5300000 RIPRAP AND ARTICULATING CONCRETE BLOCK REVETMENT SYSTEMS  
COMMENTS FROM INTERNAL/INDUSTRY REVIEW

Cheryl Hudson  
State Structures Design Office  
850-414-5332

**3. 530-1.2 (3<sup>rd</sup> paragraph):** Revise to require installed as tested language.

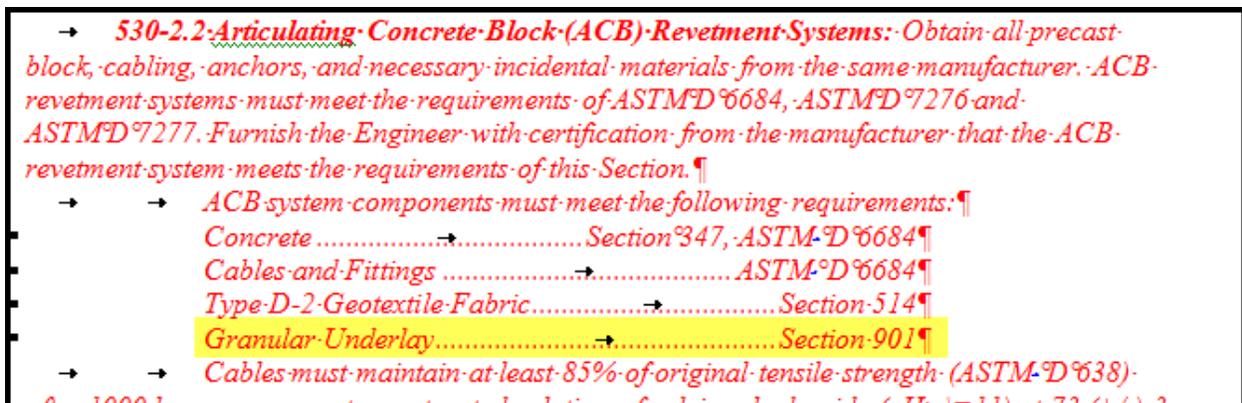
**APL Certified Tests** - The draft specification requires that all ACB products be listed on the Department’s Approved Products List (APL). This section establishes requirements of the APL including the need to submit hydraulic test reports and certification from an independent test laboratory. The primary components of the design section utilized in the laboratory testing can vary from one manufacturer to another. For example, a drainage layer may have been utilized to facilitate the relief of pore pressure and/or a substantially unique and special, non-standard geotextile may have been used. Considering this, we request that the requirements of the APL be expanded to require the approved block/system be installed in a manner that is consistent with how it was tested.

Response: The testing is not intended to replicate the variations of site specific conditions, but

instead the block hydraulic properties. ASTM D 6884 covers installation methods. No change.
